Executive Director's Recommendation

Commission Meeting: September 7, 2023

PROJECT National Desert Shield and Desert Storm Memorial Updates National Mall 23rd Street and Constitution Avenue, NW Washington, DC	NCPC FILE NUMBER 7745
SUBMITTED BY United States Department of the Interior, National Park Service	NCPC MAP FILE NUMBER 1.44(73.10)45710
REVIEW AUTHORITY Commemorative Works per 40 U.S.C. § 8905	APPLICANT'S REQUEST Approval of revised final site development plans
	PROPOSED ACTION Approve revised final site development plans
	ACTION ITEM TYPE Staff Presentation

National Desert Shield and Desert Storm Memorial Updates

Site Overview – Design Updates

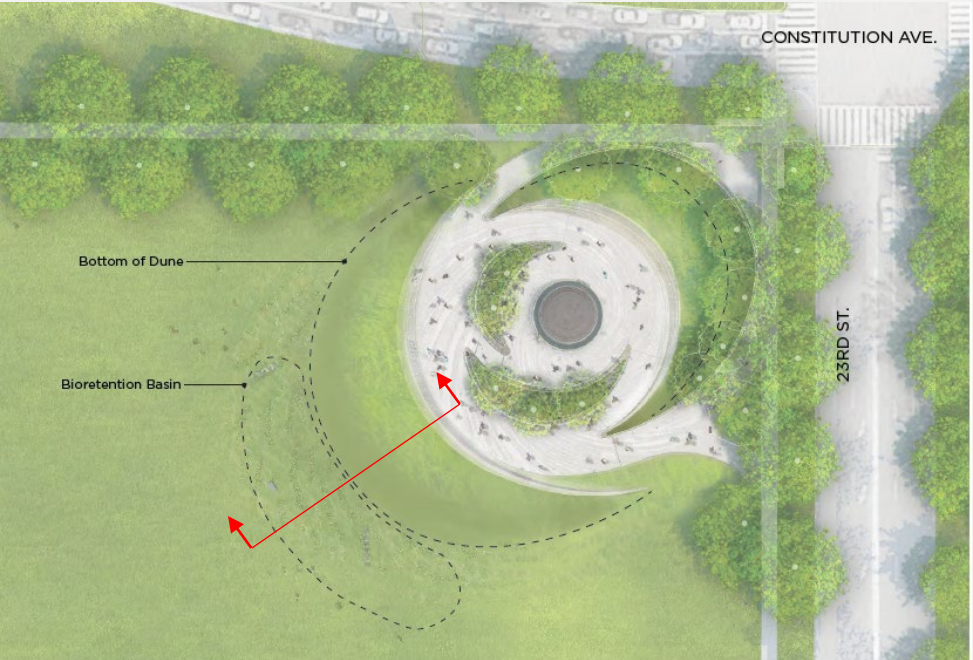
Notes the originally-approved design intended to capture and reuse rainwater to irrigate the Memorial's planted areas. The revised design proposes to treat rainwater via bioretention and use potable water for irrigation.

Encourages limited use of the proposed irrigation system after plantings are established to reduce potable water use.

Staff recommends the Commission **notes the originally-approved design intended to capture and reuse rainwater to irrigate the Memorial's planted areas. The revised design proposes to treat rainwater via bioretention and use potable water for irrigation.** The bioretention area is proposed at the southwest portion of the site, at the bottom of the "dune" berm. It is designed to provide a seamless visual transition between the adjacent lawn/recreation area and the carex plantings proposed on the berm with additional carex species that will maintain an evergreen appearance and grow to a mature height that would conceal the approximate two-foot depth of the bioretention basin. The size of the bioretention basin is dictated by the associated drainage area, functional side slope requirements, and feasibility of grade tie-ins to the larger memorial site.

NPS indicated that incorporation of the bioretention area allows for the removal of the previously proposed irrigation skid and cistern, resulting in a more efficient, cost-effective, and maintenance-friendly stormwater management system. Staff suggests the Commission **encourages limited use of the proposed irrigation system after plantings are established to reduce potable water use.** This is an environmentally sensitive approach that balances water conservation with the need for irrigation as plants develop their root systems over the first two- to three- growing seasons.

Pedestrian Safety

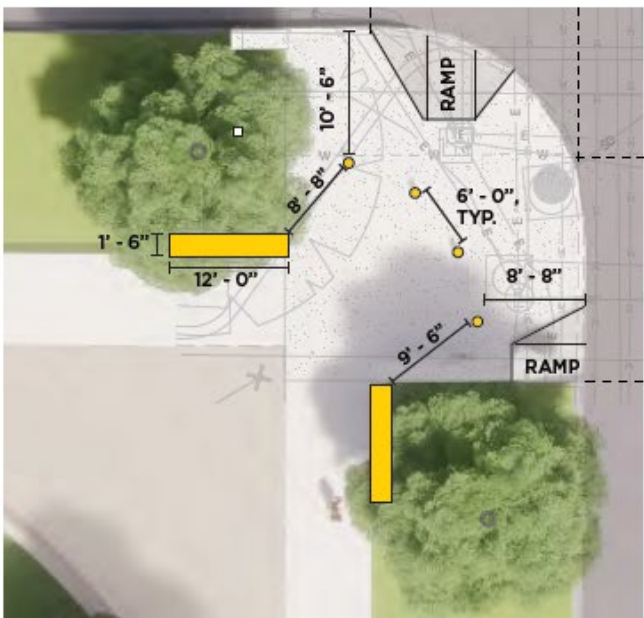
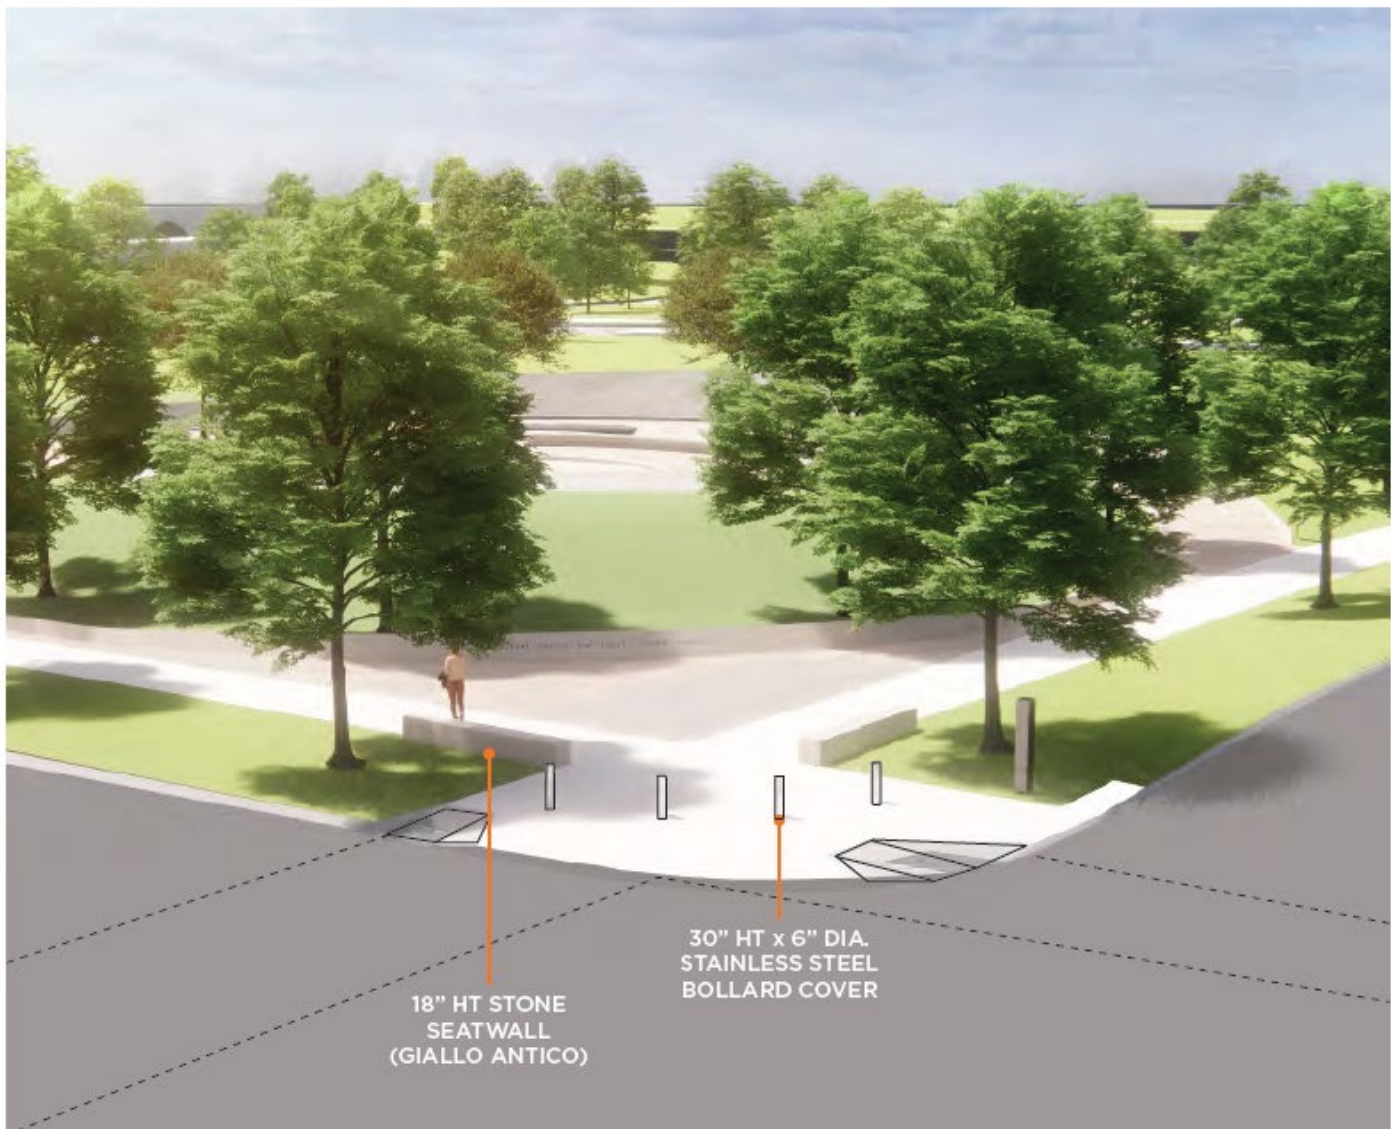
Recommends that if NPS and the U.S. Park Police determine pedestrian safety improvements are necessary on the east corner of 23rd Street and Constitution Avenue in the future, those improvements should be complimentary to the current proposal.

The proposal includes the addition of four stainless steel bollards located approximately eight to ten feet behind the curb line. The bollards themselves will measure 30 inches in height and six inches in diameter and will be spaced six feet apart. Two stone seat walls are also included in the pedestrian safety improvements. The stone walls would measure 12 feet long and 18 inches in both depth and height. They are proposed in alignment with the inner edge of the north and east street tree wells located nearest to the corner of 23rd Street and Constitution Avenue. The stone used for the seat walls will be slabs of Giallo Antico granite, which is the same granite being used throughout the Memorial design. Overall, staff recommends the Commission **finds the proposed pedestrian safety improvements are complimentary to the Memorial and the streetscape. Similar safety measures are used at the United States Institute of Peace site located just north of the intersection.** The addition of bollards and seat walls serve as a visual deterrent to potentially errant high-speed vehicular traffic (i.e. vehicles turning left onto 23rd Street from Constitution Avenue), as requested by the United States Park Police.

In addition, the Global War on Terrorism Memorial is being considered on the site immediately opposite of the Memorial on the east side of 23rd Street, NW. Therefore, staff suggests the Commission **recommends that if NPS and the U.S. Park Police determine pedestrian safety improvements are necessary on the east corner of 23rd Street and Constitution Avenue in the future, those improvements should be complimentary to the current proposal.**

Finds the proposed pedestrian safety improvements are complimentary to the Memorial and the streetscape. Similar safety measures are used at the United States Institute of Peace site located just north of the intersection.

Flagpole

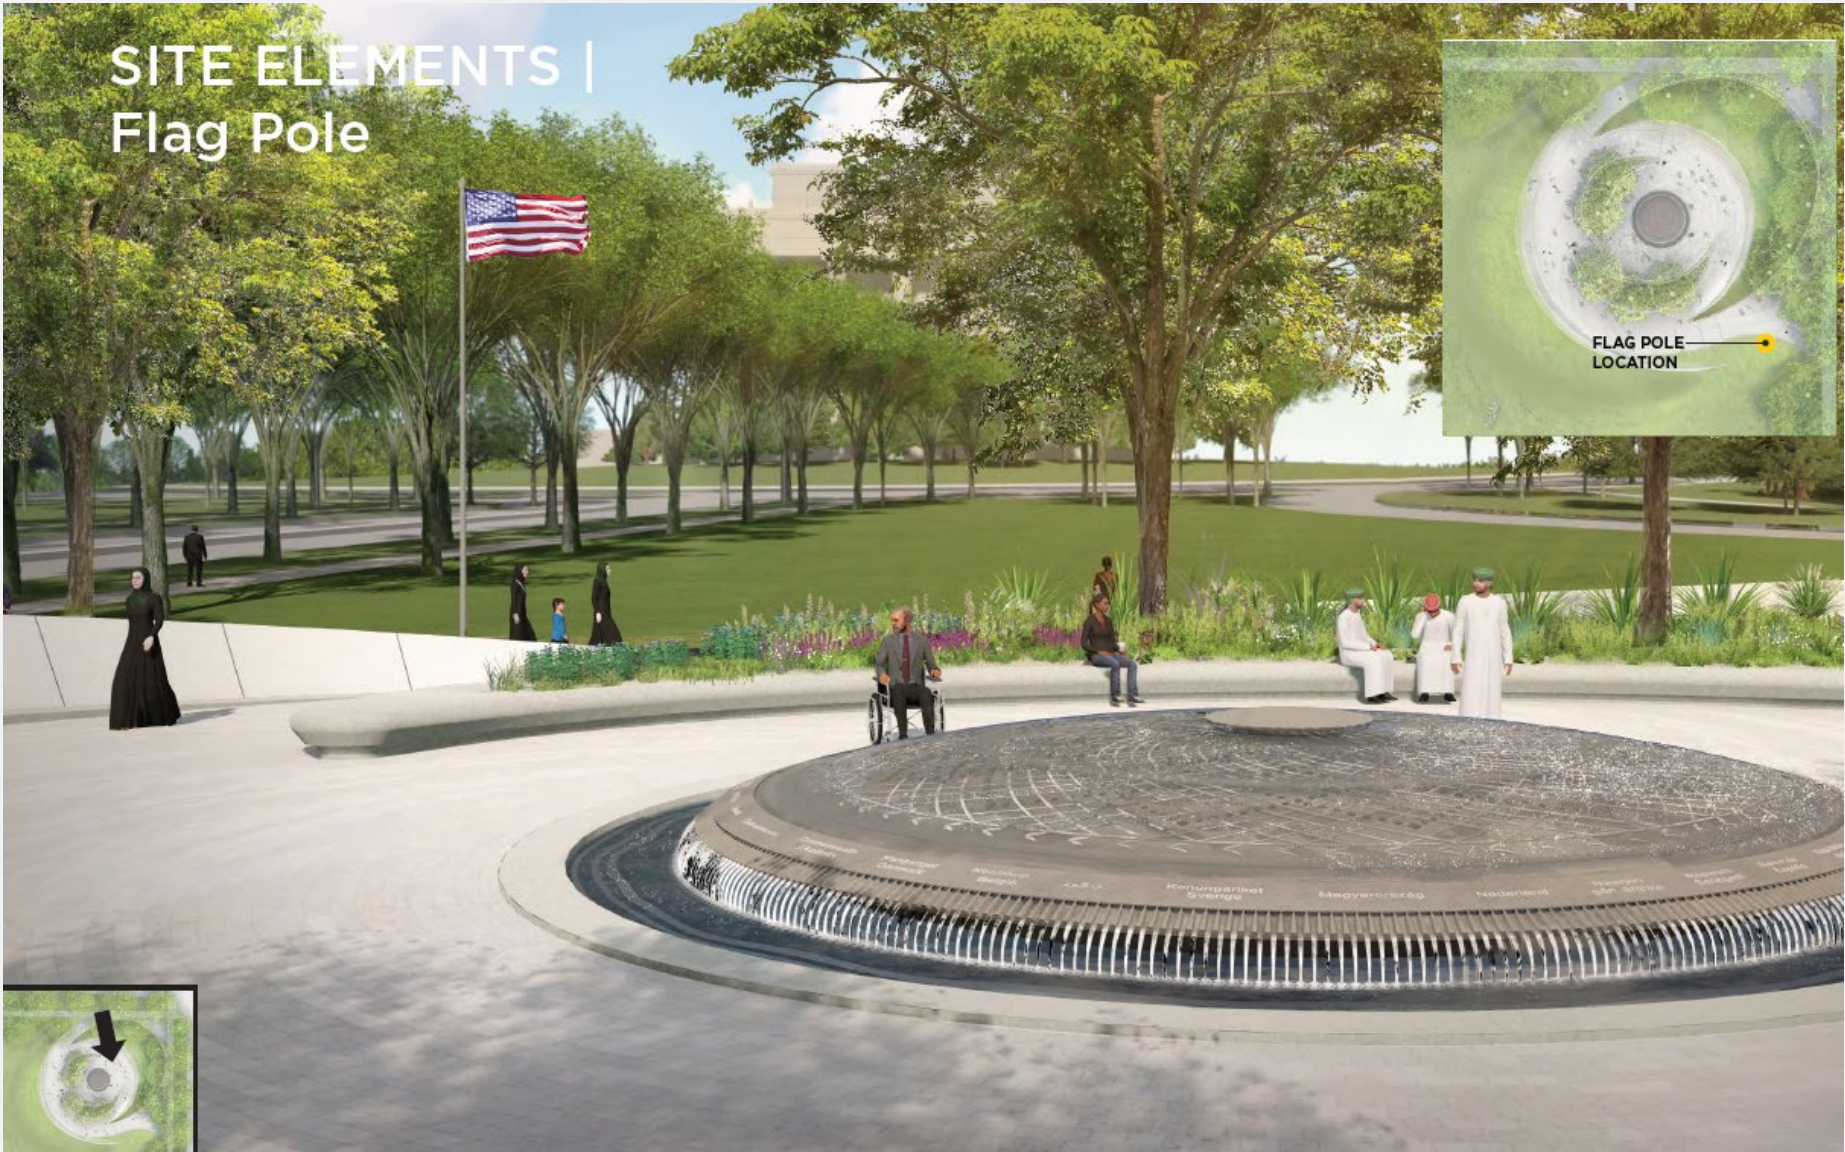
Supports incorporating a flagpole on the Memorial site and finds the proposed location does not interrupt views of the Lincoln Memorial.

A 25-foot height flagpole is proposed near the main entrance to the Memorial on 23rd Street, in alignment with the street trees. NPS indicates that the flagpole will serve to reinforce the historic integrity of the Memorial site and its relationship to other war memorials in the vicinity. Overall, staff recommends the Commission **supports incorporating a flagpole on the Memorial site and finds the proposed location does not interrupt views of the Lincoln Memorial.**

Planting Palette - Overall

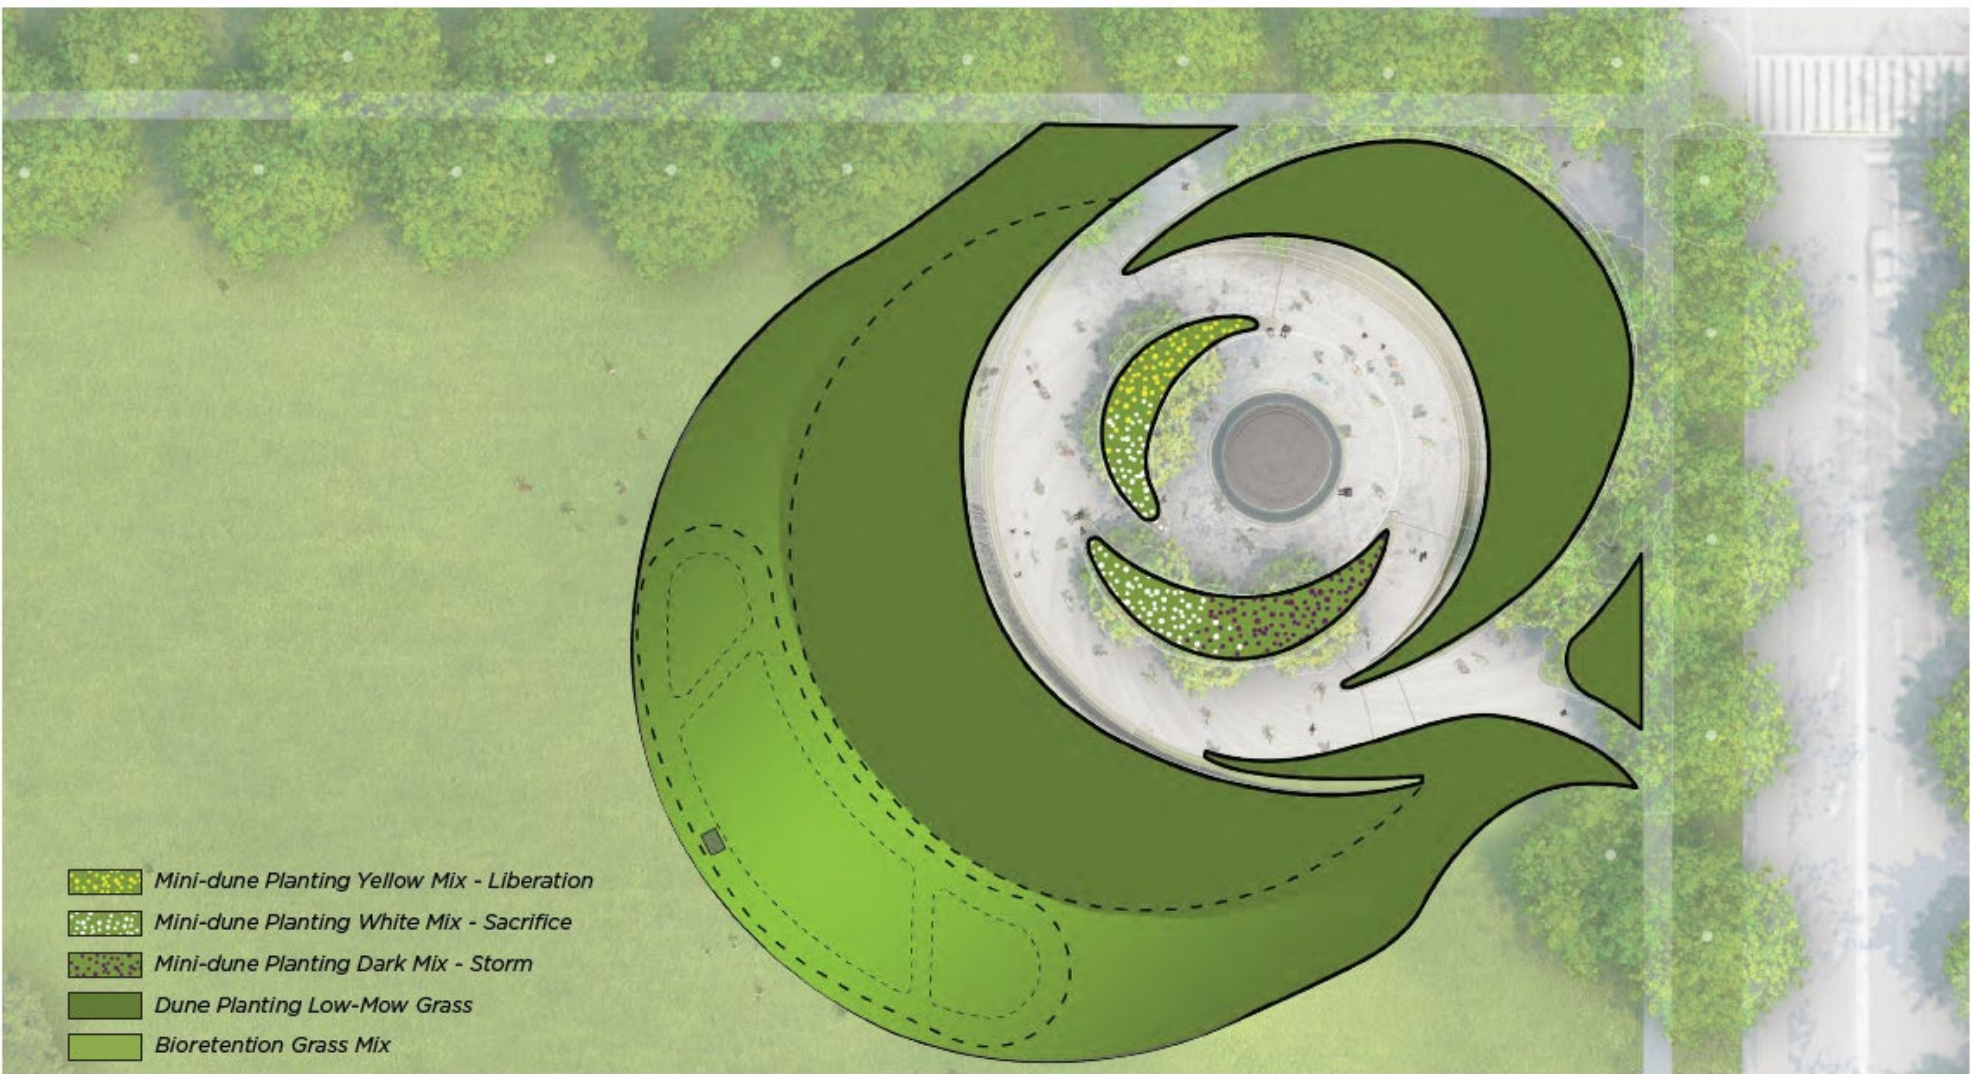
Notes the refined planting palette uses pollinator-friendly species, including milkweed, in response to Commission comments.

The planting palette is updated to include diversified tree species and a simplified palette of the interior “mini dune” plantings to resemble a desert oasis and incorporate milkweed species, in response to feedback received from the Commission of Fine Arts and the Commission at its December 2022 final review. Overall, staff **notes the refined planting palette uses pollinator-friendly species, including milkweed, in response to Commission comments.**
